Access Compliance Report

Public Rights-of-Way

(Curb Ramps)

Intersection ID: 22436	Main Street: CHADMORE_SOUTH_DR	Cross Street: WILBY_HOLLOW_DR	Location: E
ADA ID: 32D142B20E13	Ramp Type: Perp	Initial Pass/Fail: Fail	Overall Compliance: No
Severity Score: 13.75			
Codes/Mitigation Info/Possible Solution		Field Measurements/Component Compliance

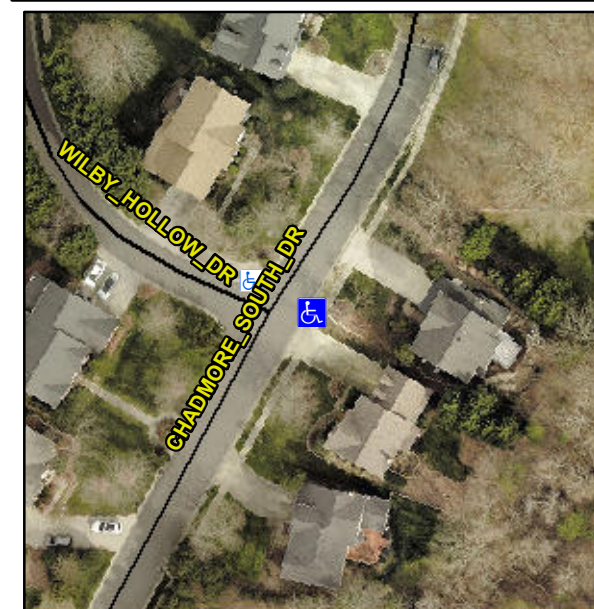
Not Found, R304.2.2, R304.5.3

Compliance	Description	Data	Compliance	Description	Data
N/A	Ramp Length (in)	43.0	No	Ramp Slope (%)	11.9
Yes	Ramp Width (in)	74.0	No	Ramp XSlope (%)	2.2
N/A	Flare Type LT	N/A	N/A	Flare Type RT	N/A
N/A	Flare Slope LT (%)	N/A	N/A	Flare Slope RT (%)	N/A
N/A	Flare Traversable LT?	N/A	N/A	Flare Traversable RT?	N/A
N/A	Landing Length (in)	N/A	N/A	DWS Provided?	N/A
N/A	Landing Width (in)	N/A	N/A	DWS Contrast?	N/A
N/A	Landing Slope (%)	N/A	N/A	DWS Length (in)	N/A
N/A	Landing X Slope (%)	N/A	N/A	DWS Full Width?	N/A
N/A	Landing Curb? (Y/N)	N/A	N/A	DWS Offset (in)	N/A
N/A	Shared Landing?	N/A			
N/A	Gutter Ponding?	N/A	N/A	Gutter Slope (%)	N/A
N/A	Gutter Lip Ht (in)	N/A	N/A	Gutter X Slope (%)	N/A
N/A	Painted X Walk1?	No	N/A	Painted X Walk2?	N/A
	X Walk 1 Direction	To NW		X Walk 2 Direction	N/A
N/A	X Walk 1 Width (in)	N/A	N/A	X Walk 2 Width (in)	N/A
	X Walk 1 Slope (%)	3.9		X Walk 2 Slope (%)	N/A
	X Walk 1 X Slope (%)	1.8		X Walk 2 X Slope (%)	N/A

Remove & Replace Entire Ramp.
